# UNITED STATES PATENT AND TRADEMARK OFFICE

### Office Action Summary

10/809,138

## DETAILED ACTION

Figure 2 of Litvin et al.

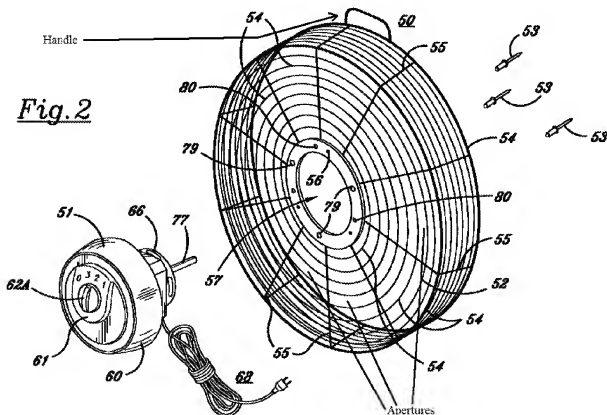
3. In re claim 1, Litvin et al. discloses a grill (52) configured to be mounted on a surface of a fan or fan housing, the grill comprising a substantially planar portion, and a handle (see Figure 2 of Litvin et al.) extending out of the planar portion so as to extend away from the surface of the fan or fan housing when the grill (52) is mounted thereon.

4. In re claim 2, Litvin et al. discloses the grill (52) of Claim 1, wherein said substantially planar portion comprises a plurality of apertures (see Figure 2 of Litvin et al.).

5. In re claim 3, Litvin et al. discloses the grill (52) of Claim 2, wherein at least some of said plurality of apertures (see Figure 2 of Litvin et al.) are arranged in a grid.

16. In re claim 25, Litvin et al. discloses the grill (52) of Claim 24, wherein two of the sections of wire arranged to provide support (55) for the at least one loop or partial loop (54) define an aperture (see Figure 2 of Litvin et al.) in said fan grill (52), the aperture being capable of receiving the handle of a second, similar fan grill (52).

18. In re claim 27, Litvin et al. discloses a fan assembly (50) comprising a housing having an aperture, a fan (not shown) mounted within the housing adjacent the aperture (see Figure 2 of Litvin et al.) and a grill (52) mounted over the aperture the grill (52) comprising a substantially planar portion and a handle (see Figure 2 of Litvin et al.) extending out of the planar portion and away from the fan housing

Figure 3 of Litvin et al.

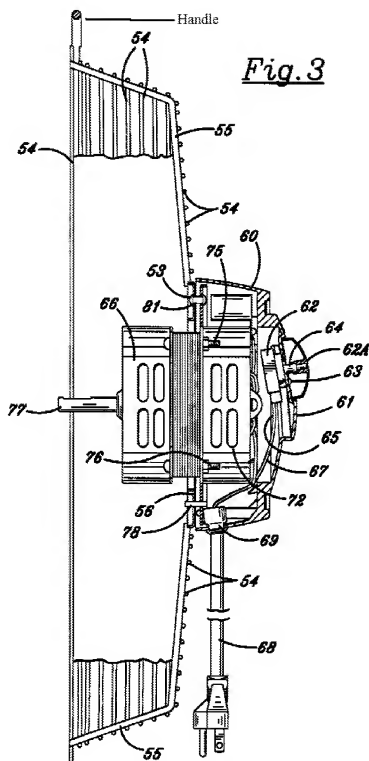
13. In re claim 18, Litvin et al. discloses the grill (52) of Claim 17, wherein the section of wire forming the handle portion extends away from said common plane (see Fig. 3 of Litvin et al.), and wherein either end of that section wire is attached to said outermost loop (54).

Figure 2 of Bull et al.

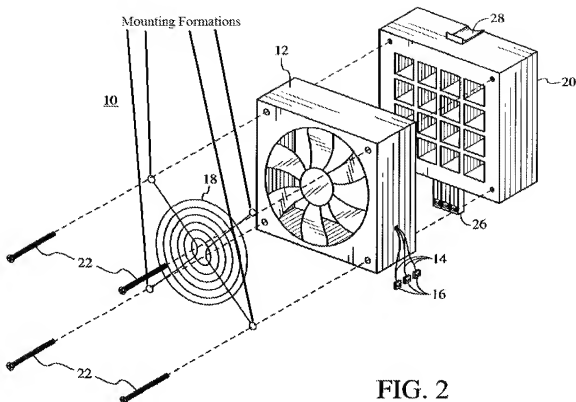
22. In re claim 12, Litvin et al. discloses all the limitations of claim 12 except at least one of the mounting formations comprising shaped wire extending away from said planar portion and arranged to form a loop or partial loop as set forth in the claim. Bull et al. teaches at least one mounting formation (see Fig. 2 of Bull et al.) comprising shaped wire extending away from said planar portion and arranged to form a loop or partial loop (see Fig. 1 and Fig. 2 of Bull et al.) for the purpose of mounting the grill to the fan housing.

23. It would have been obvious to one having ordinary skill in the art at the time the invention was made to combine at least one mounting formation (see Fig. 2 of Bull et

26. In re claim 22, Litvin et al. discloses all the limitations of claim 22 except a support and a mount that are formed from a common section of wire. Bull et al. discloses a support and a mount formed from a common section of wire (see Fig. 1 and Fig. 2 of Bull et al.).

Figure 2 of Fritschle et al.

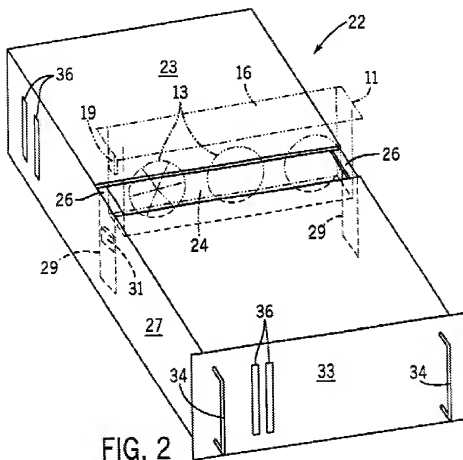
29. In re claim 9, Litvin et al. discloses all of the limitations of claim 9 except a handle comprising at least one additional piece of wire, each additional piece of wire being shaped such that it is substantially parallel to said first piece of wire over the length of that additional piece of wire. Fritschle et al. teaches a handle comprising an additional piece of wire (34) being shaped such that it is substantially parallel to said first piece of wire over the length of that additional piece of wire (see Fig. 2 of Fritschle et al.).

30. It would have been obvious to one having ordinary skill in the art at the time the invention was made to combine a handle comprising at least one additional piece of wire (34), each additional piece of wire being shaped such that it is substantially parallel to said first piece of wire over the length of that additional piece of wire with the grill taught in claim 8 as disclosed by Litvin et al. for the purpose of making the assembled unit easier to carry.
